VALUE ENGINEERING CONSTRUCTABILITY STUDY
OF
I-64 MAJOR WIDENING
from EAST of VAN METER ROAD to EAST of the
MOUNTAIN PARKWAY

ITEM NUMBER: 7-33.00

Clark County, Kentucky

Prepared by:
VE GROUP, L.L.C.

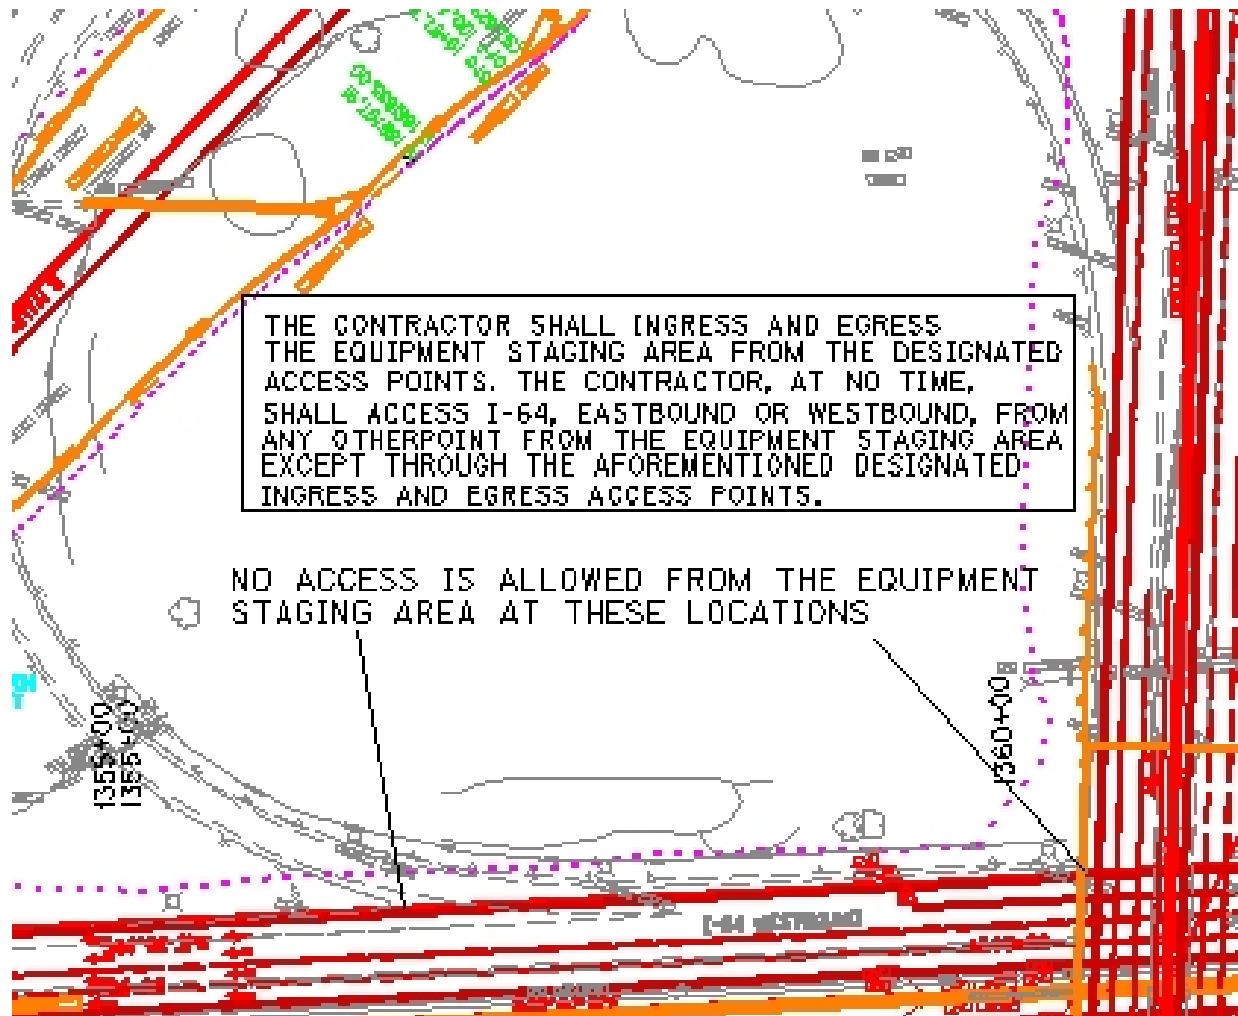
The As Proposed consists of utilizing notes pertaining to the movement of construction equipment from certain staging areas.

The Value Engineering Alternative consists of using a plan sheet in conjunction with notes to show equipment movement from the staging areas.
